ADMINISTRATIVE APPLICATION CHECKLIST

Well
 Goldenspur 36 WI 224
 30-015 - pending

SUBJECT: REQUEST FOR APPROVAL OF NON-STANDARD LOCATION FOR GOLDEN SPUR 36
COM W1 2H

WELL LOCATION AND ACREAGE DEDICATION PLAT

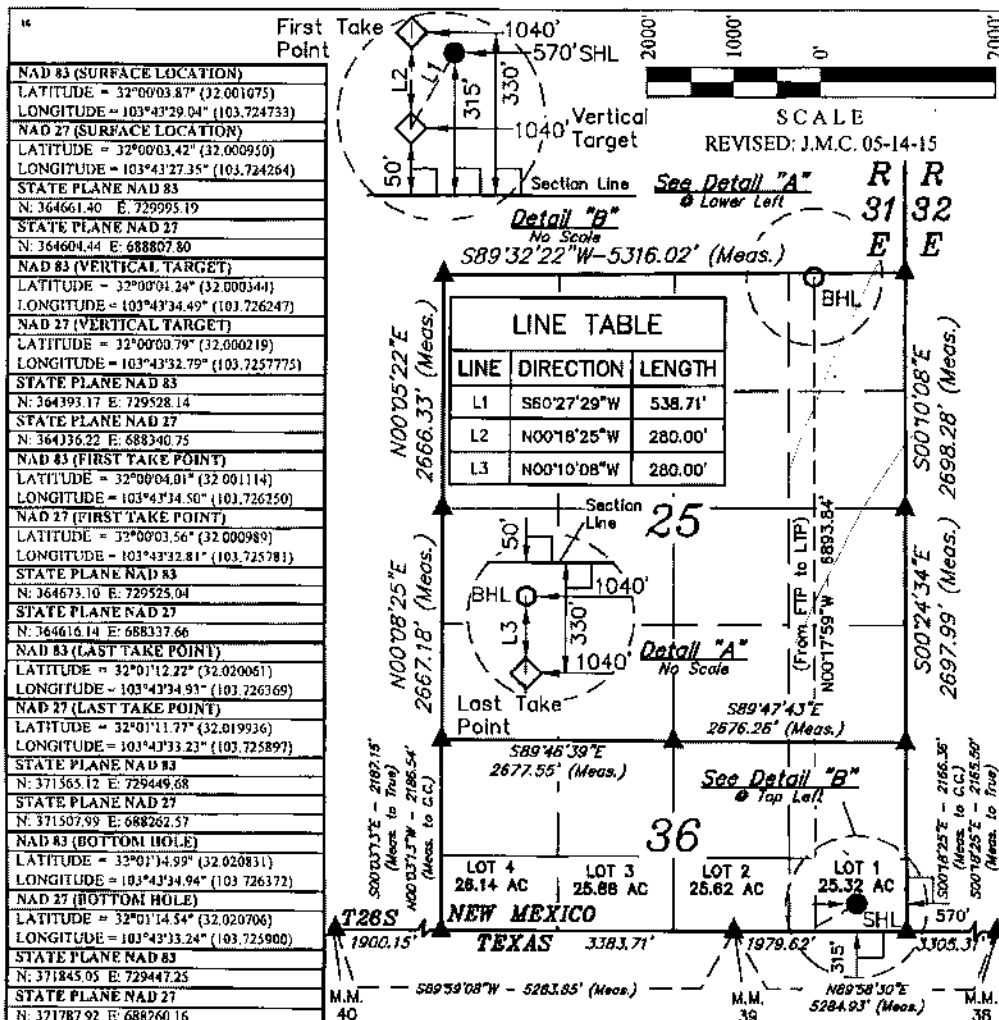
Why is the NSL location better than a standard location? This would be the reason for NSL application.
Mike

Why are you applying for the NSL?
Is the NSP required, because the Lot in Section 36 is less than 28-acres?
Thank You
Michael McMillan

Do we want overlapping project areas-we would be giving TWO allowables for each spacing unit in Section 25,
Mike

The Bureau of Land Management encouraged this location to be used because of cave/karst considerations and to avoid nearby drainage ditches. The granting of this request is not expected to cause waste of resources.

We are 50' too close to the project area (208' from project area border on the west side) and yes Lot 1 in Section 36 is less than 28 acres.
